Our Ref NW90684.004

21 February 2013

WHITE LION, WITHINGTON
REVISED ACCESS PROPOSAL

Figure 1.2

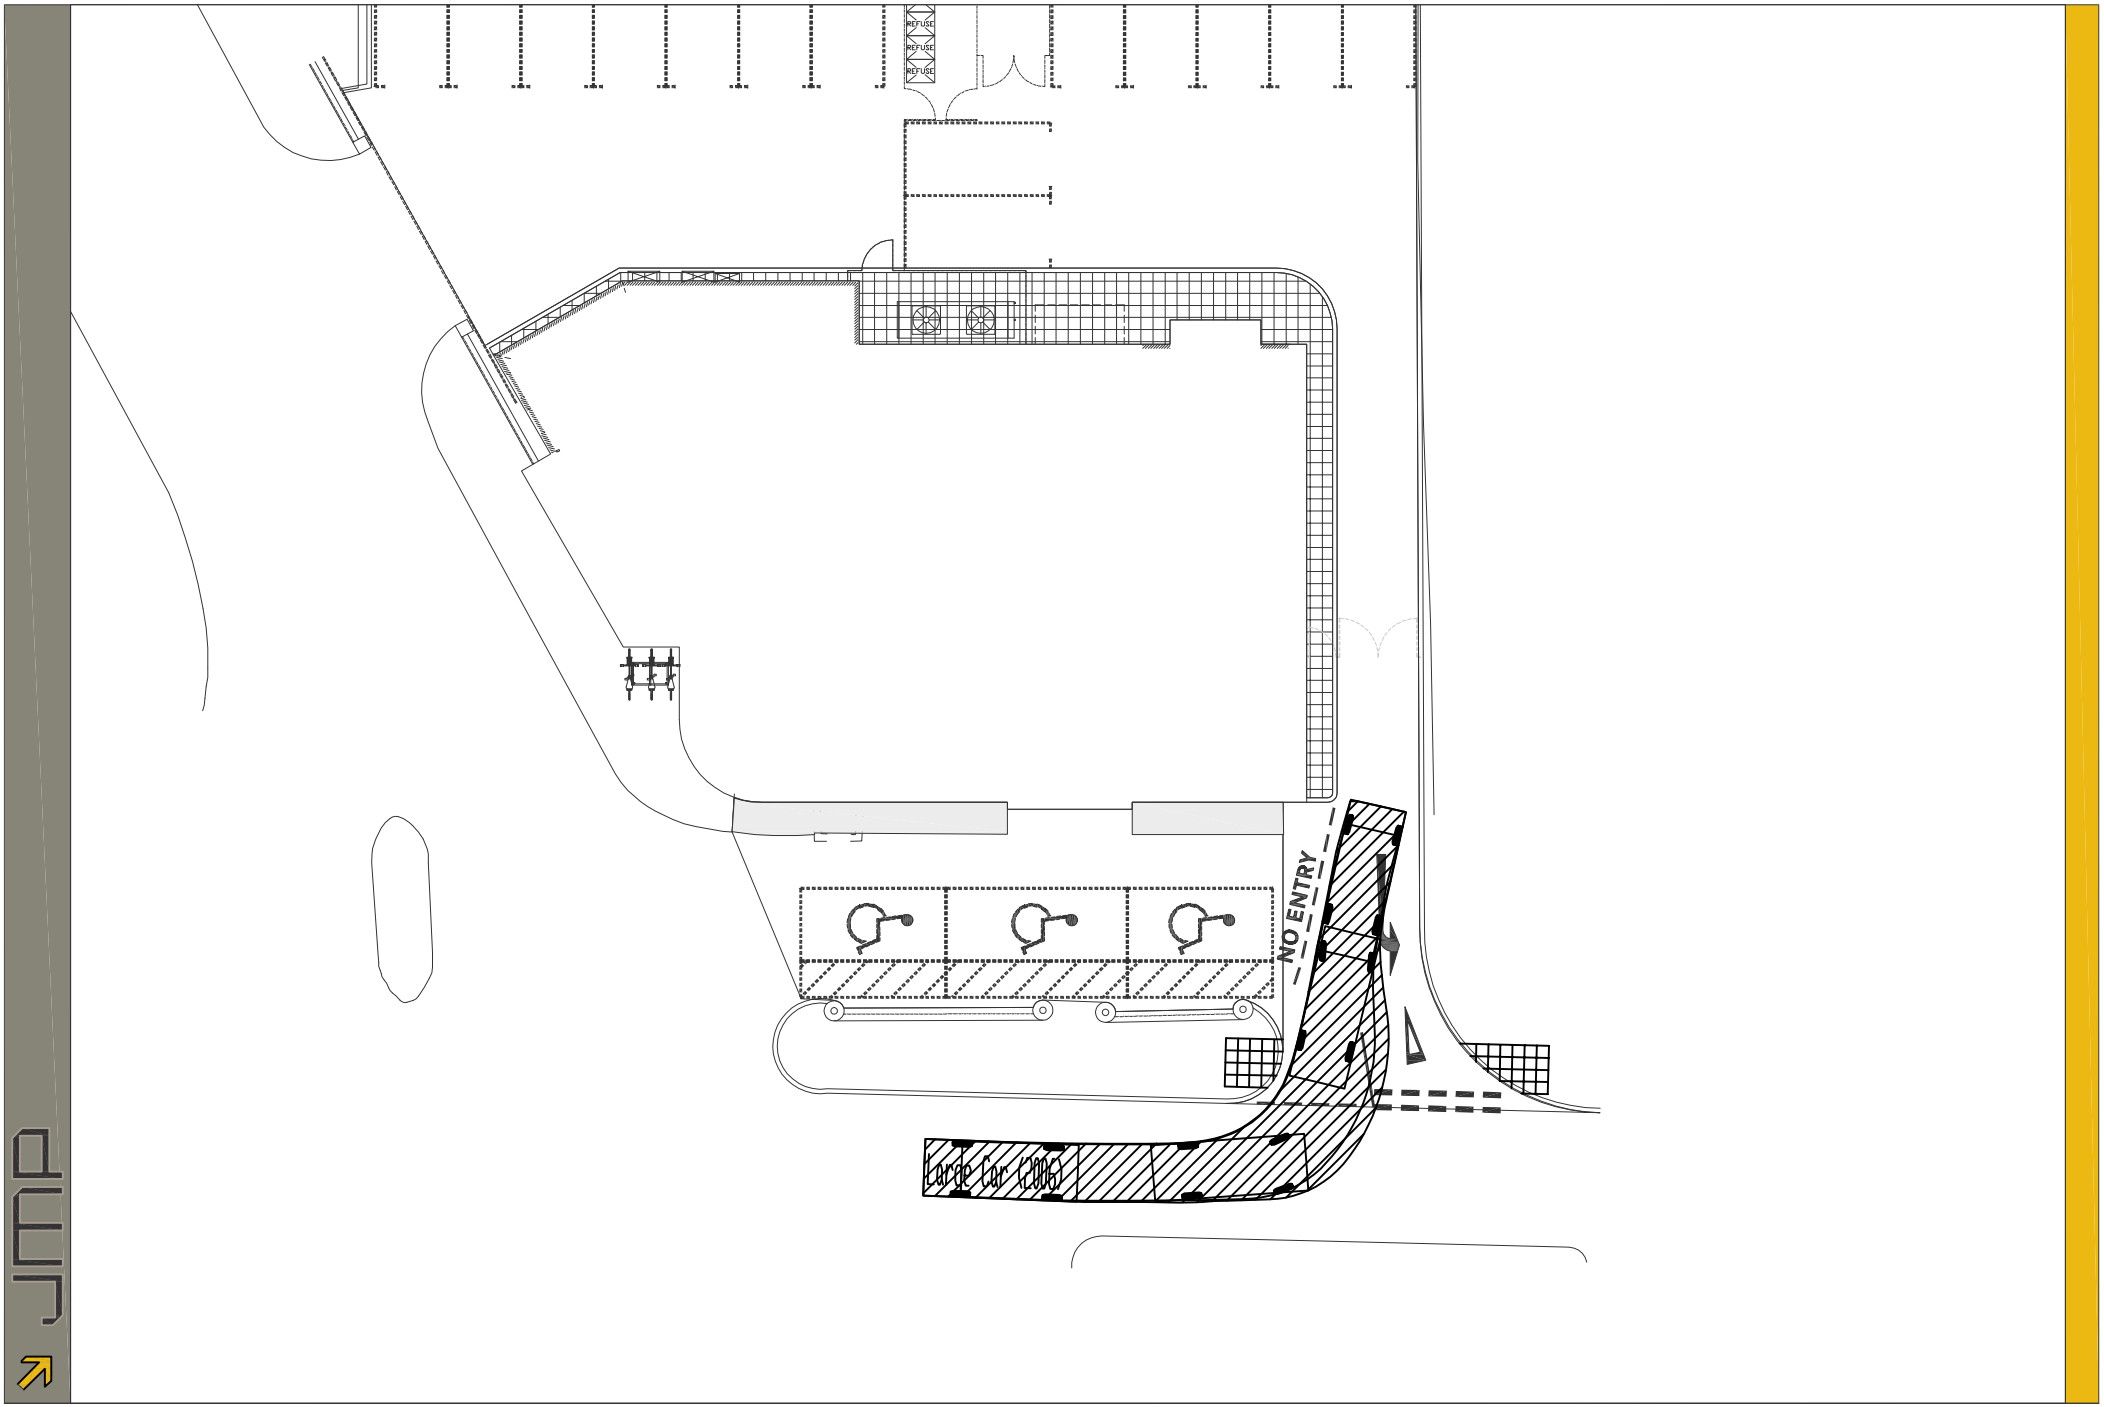
To mitigate the aforementioned issues it is proposed that the access from Wilmslow Road be reverted back to the previous kerb alignment arrangement which allowed vehicles to turn left from Wilmslow Road into the residents parking area. **Figure 1.2** demonstrates the proposals as well as illustrating the vehicle tracking of a large family car.

We don't see any major issue with the adjustment- it will improve the accessibility and the highway safety for the residents. The only minor concern is pedestrians having to check behind them for approaching vehicles, but this is no different to other accesses throughout the city. Please note any amendments required on the adopted highway must go through our "Contact Manchester" switchboard to allow licensed contractors to carry out the work. It is also worth contacting the planners to get a view on whether an application is required.

DRAWING NUMBER: N01915-D001

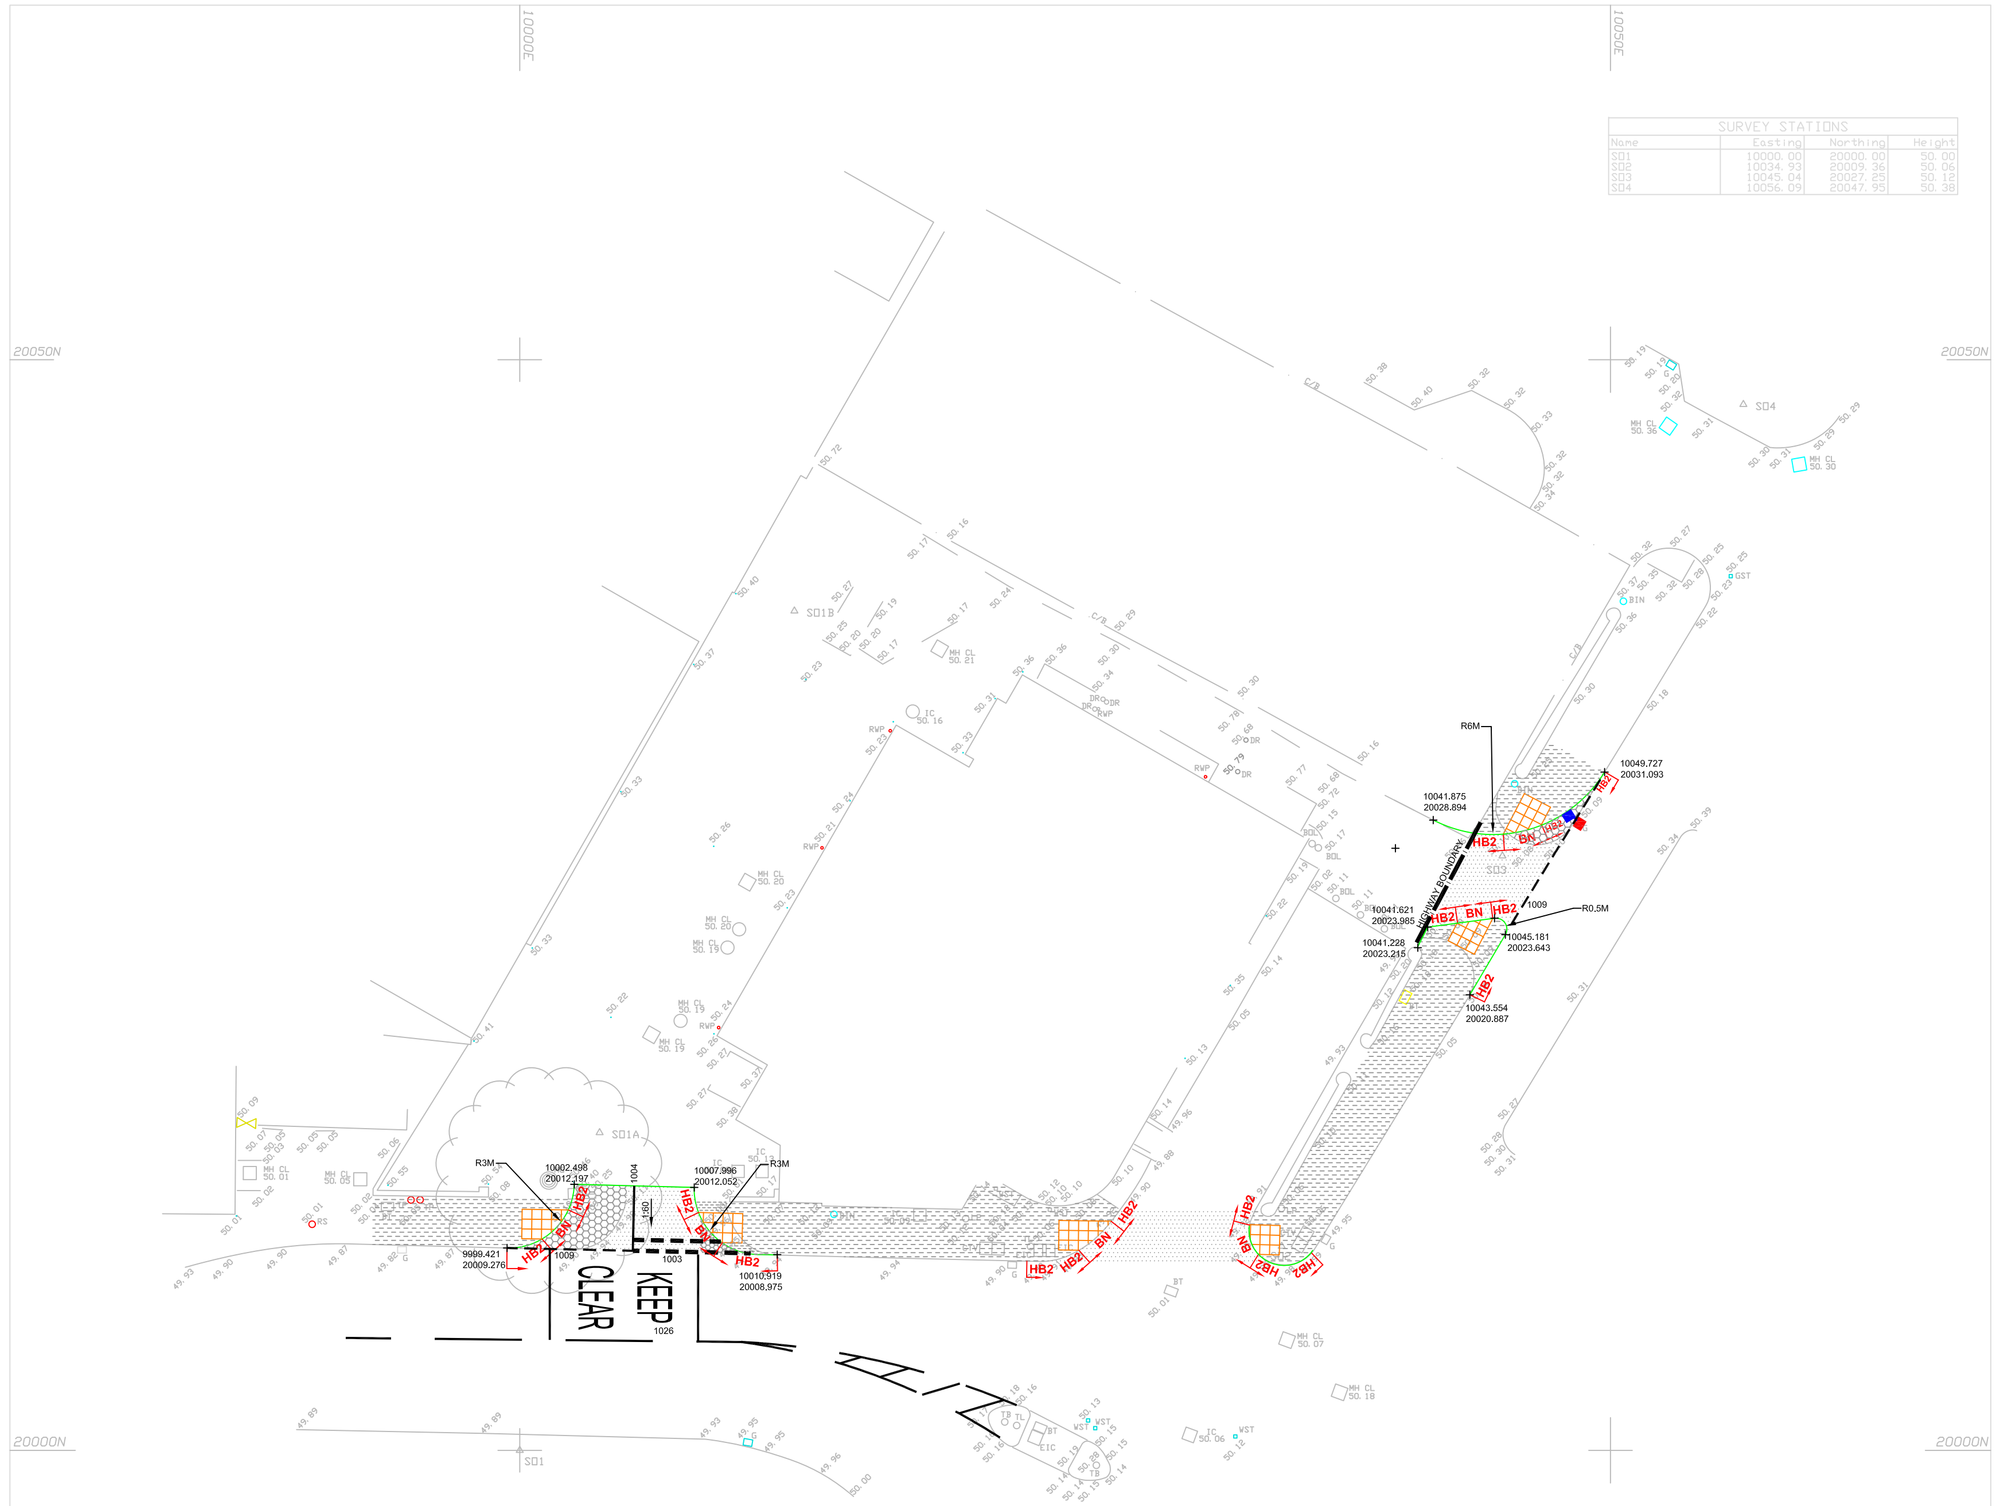
The current 'build out' arrangement (presented in attached plan N01915-D001) prevents resident's vehicles from turning left into the site from Wilmslow Road and entering the residents parking area.

Currently residents have to drive 'through' the loading/disabled parking area and adjacent the Sainsbury's front doors. As a consequence the current arrangement leads to the following issues:

- Residents are at present driving very close past the front door of the store, raising safety concerns particularly for pedestrians exiting the store;
- The existing vehicular left turn into the narrow access of the residents parking area along the NE side of the building is very tight, requiring 2-3 point turns; again raising safety concerns;
- In the event the disabled parking bays are occupied, resident's vehicular access is compromised (encouraging further dangerous manoeuvring); and
- When a service vehicle is unloading this too prohibits residents accessing the parking area safely.

Notwithstanding the above points it should be noted that vehicles exiting the site/residents car park cannot turn right due to the presence of the physical island on Wilmslow Road.
